Partial demolition and construction of a 17 storey mixed-use building comprising tourist accommodation, residential apartments, ancillary car parking, associated hospitality facilities and retail

100 North Terrace, Adelaide

DA 020/A130/20

OVERVIEW

Figure 8 - Swept paths of a Medium ridge vehicle within the proposed loading bay

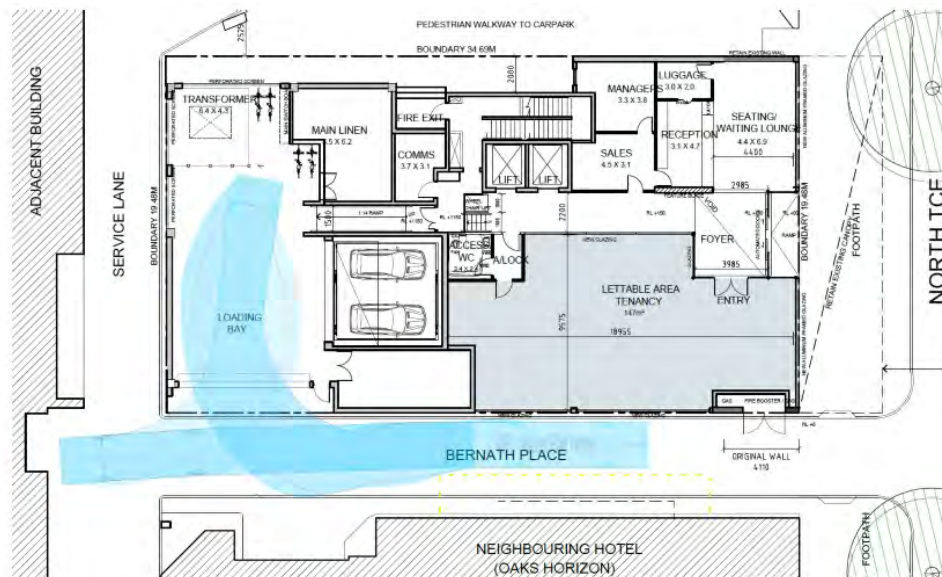
Deliveries and service vehicles will access the loading bay/back of house facilities via Bernath Place. It has been confirmed by the traffic consultant that the loading area can accommodate vehicles up to 8.8m in length which is a medium rigid vehicle. Figure 8 illustrates the typical turning path for a medium rigid vehicle within the loading bay. The vehicle will be able to enter and exit Bernath Place onto North Terrace in a forward direction, which is consistent with Council Wide PDC 242 which seeks service vehicles to enter and exit in a forward direction.

Figure 9 - Typical floor plan of the apartments in context to adjacent Oak Horizon and Embassy.

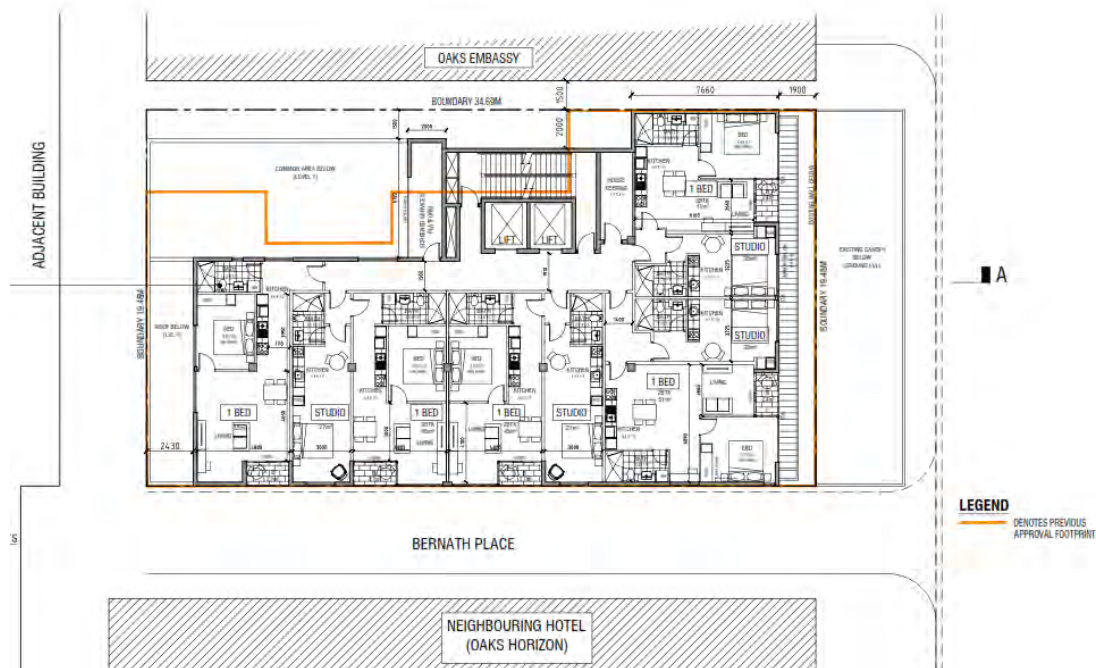
The apartment suites on the eastern elevation are set on the boundary and relies on Bernath Place to provide the separation from the adjacent Oaks Horizon, which is also set on the boundary. As a result the proposed apartments and Oaks Horizon are separated by approximately 4.55 metres, which presents a reduced level of visual and physical separation and is at odds with the Development Plan which seeks a total of 6 metres.

PROPOSED LEVEL 16 FLOOR PLAN - PENTHOUSE/ROOF PLANT
 SCALE 1:100

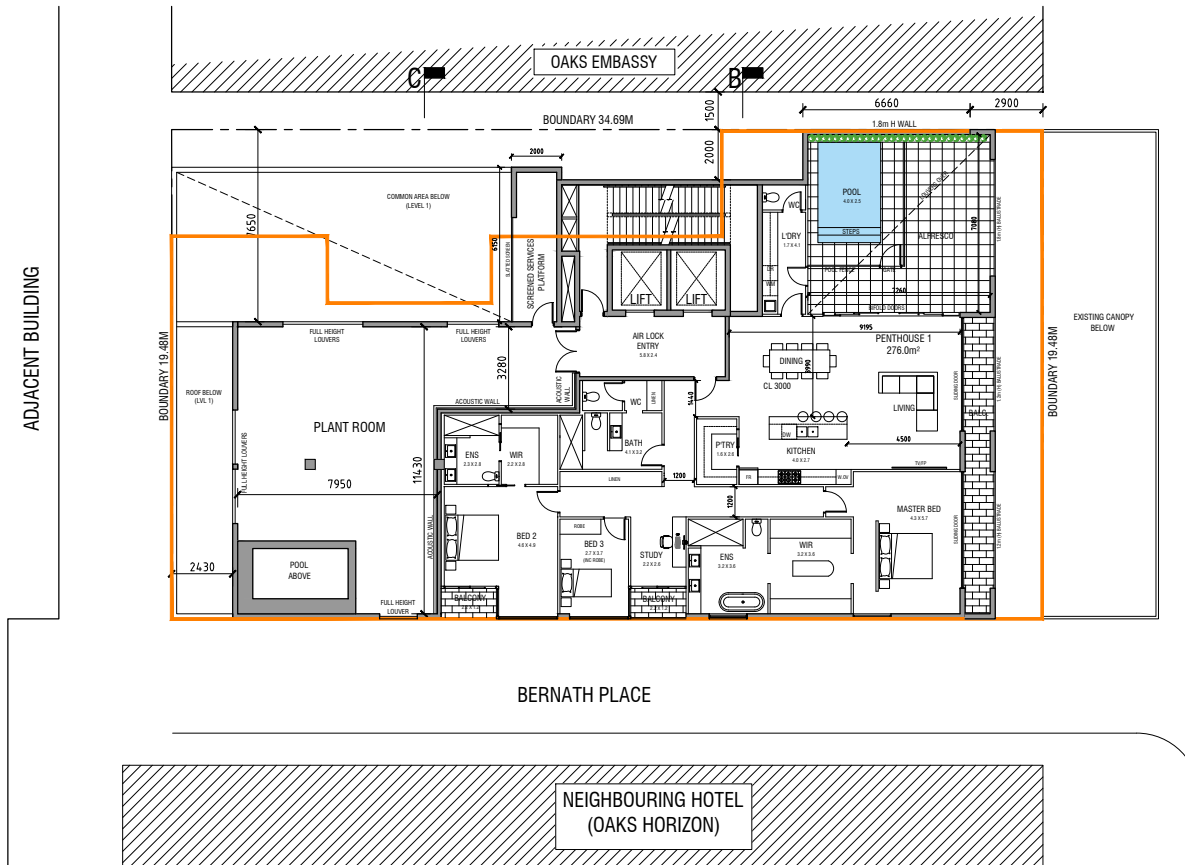
Initial concern was raised with regards to the separate plant room on level 16 and the potential acoustic impacts on the adjacent penthouse apartment. The applicant confirmed that the walls of the plant room will be double layer acoustically treated walls, which should mitigate any potential acoustic impacts.

Figure 6 - Level 17 floor plan

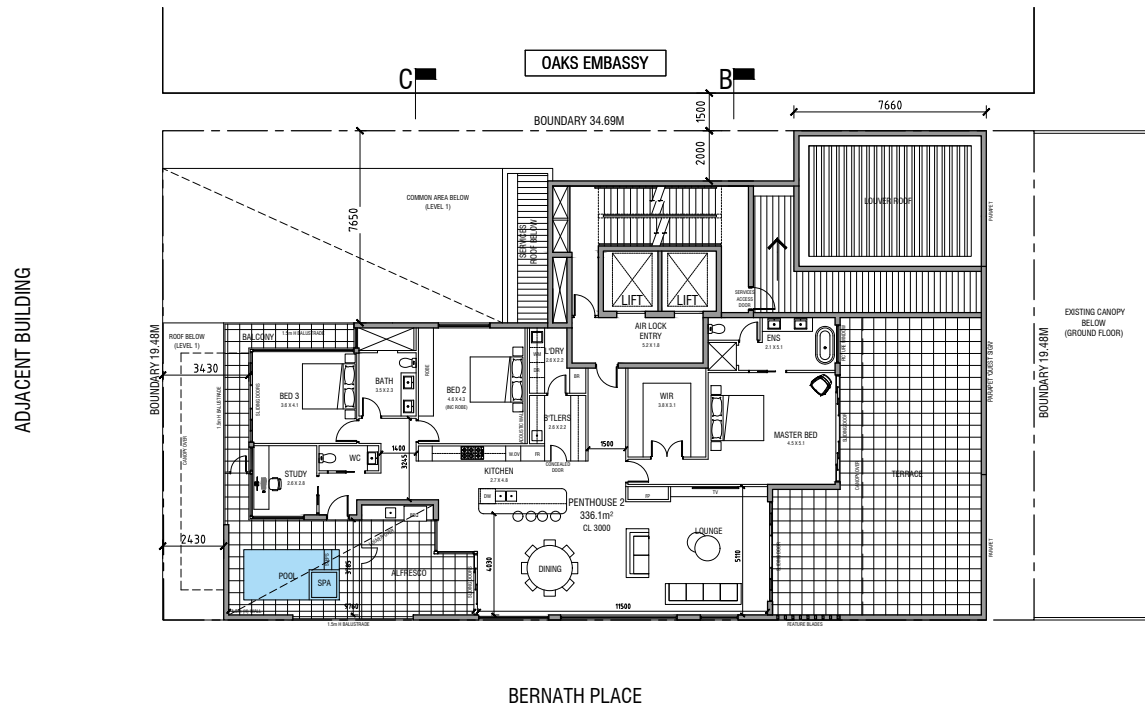
The residential penthouse apartments on levels 16 and 17 'cap' the tower element and is designed to be visually recessive. The Government Architect initially suggested further review of the level 17 penthouse apartment layout, with the view to maximise the northern aspects. Concern was also raised with the close proximity of the pool and alfresco area on level 16 to the adjoining development and the dual lift access arrangement. The applicant provided revised level 17 plans which rearranged the floor plan and maximised the northern aspects for the living/dining area (figure 6).
